MC Shell NBI port cut
 dimension change on
 part # s17e172-017

The modular coil shell opening and NBI port were reshaped to eliminate port interference with modular coils.

SIMPLFD REP: MC_NBI PORT

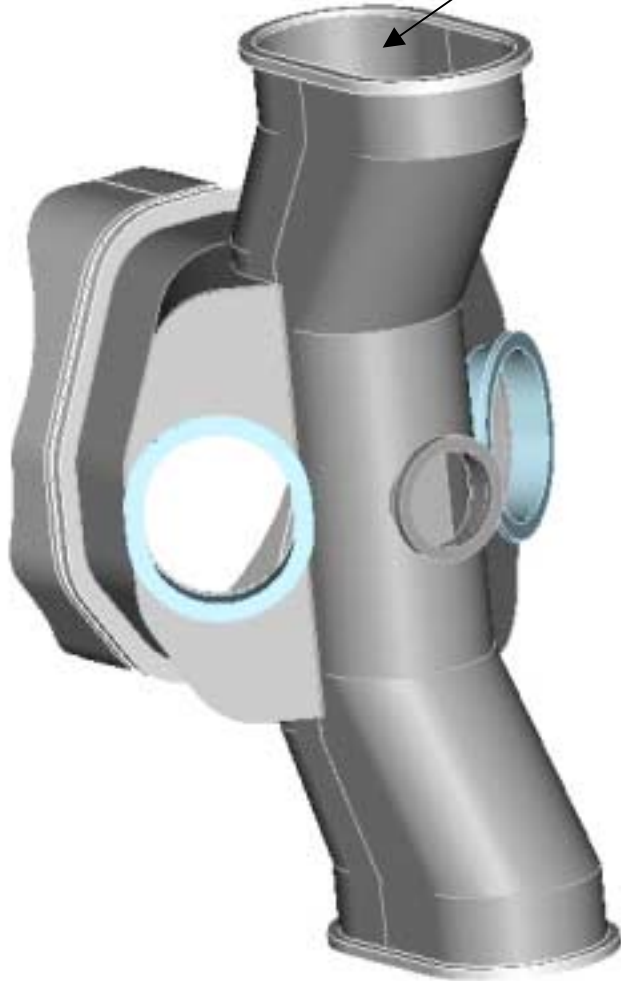
Port geometry was configured to provide clearance among port, NBI beam and modular coil.

Baseline NBI position

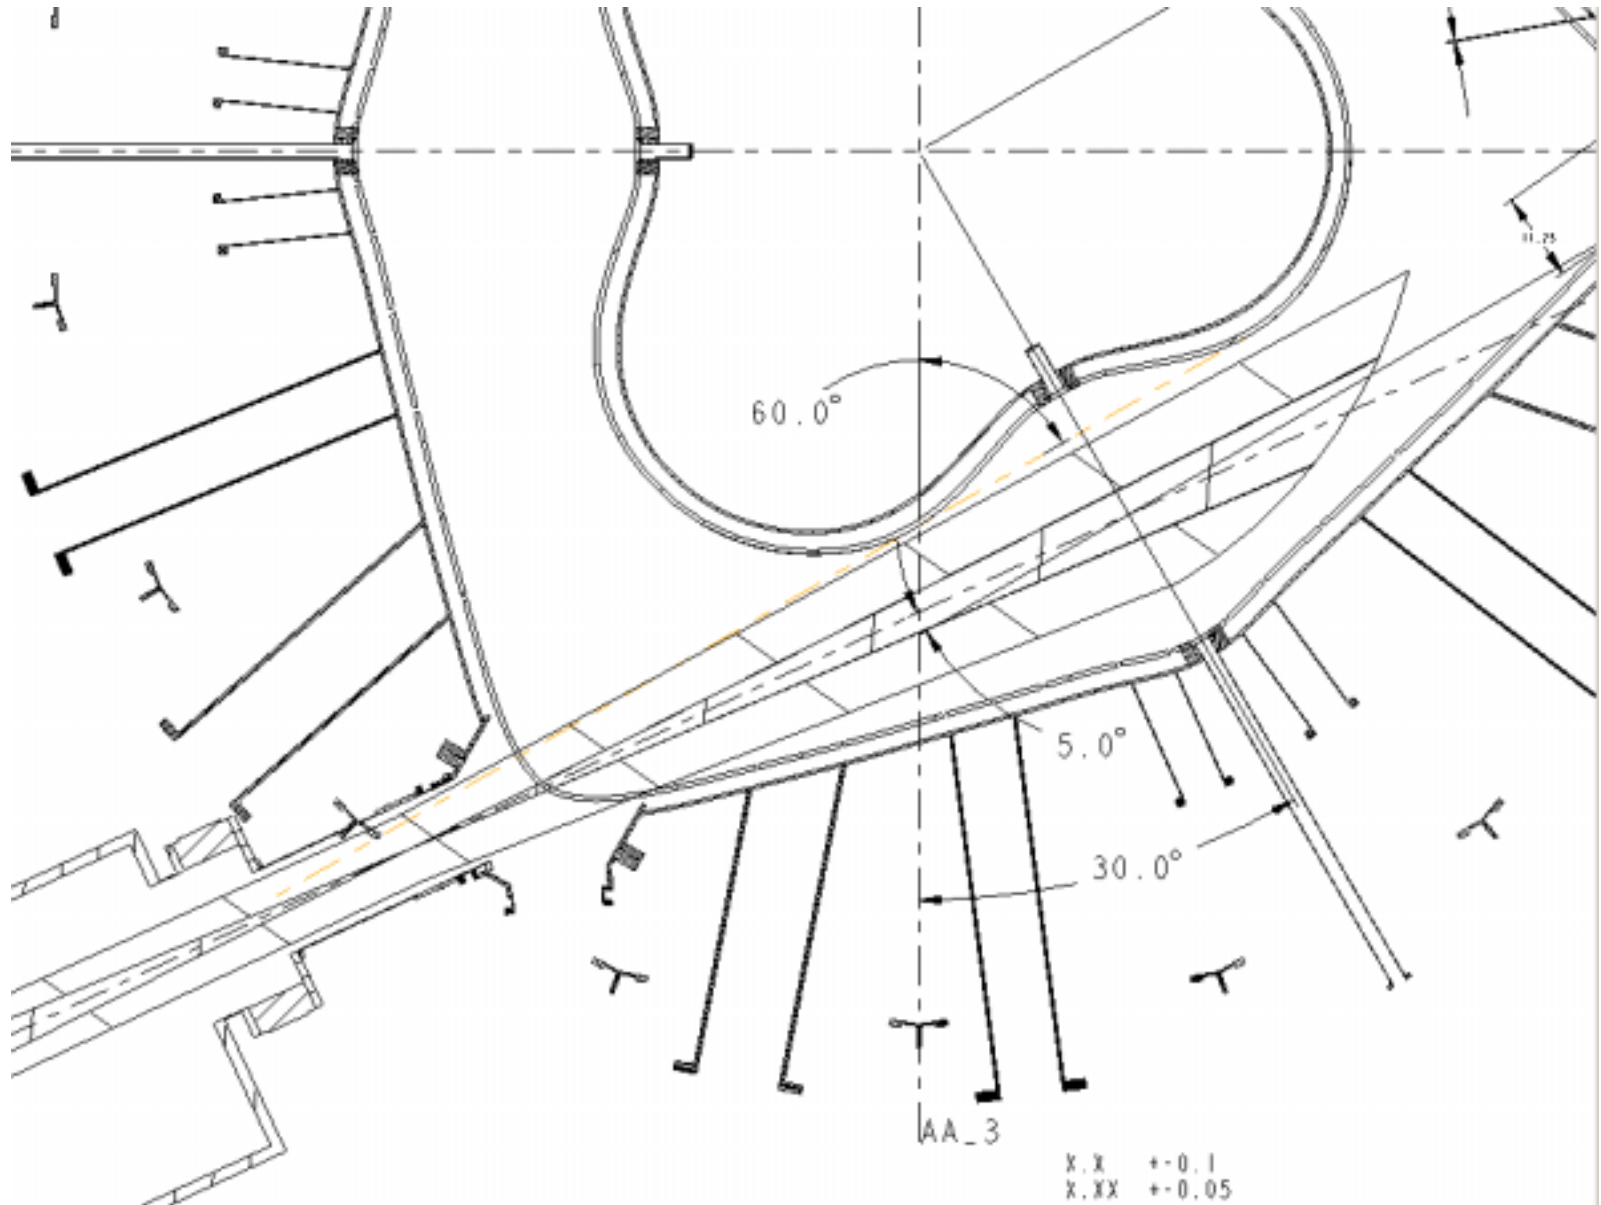
I changed the angle of the beam to 3.5 deg and the position of the locating plan to 54.20".
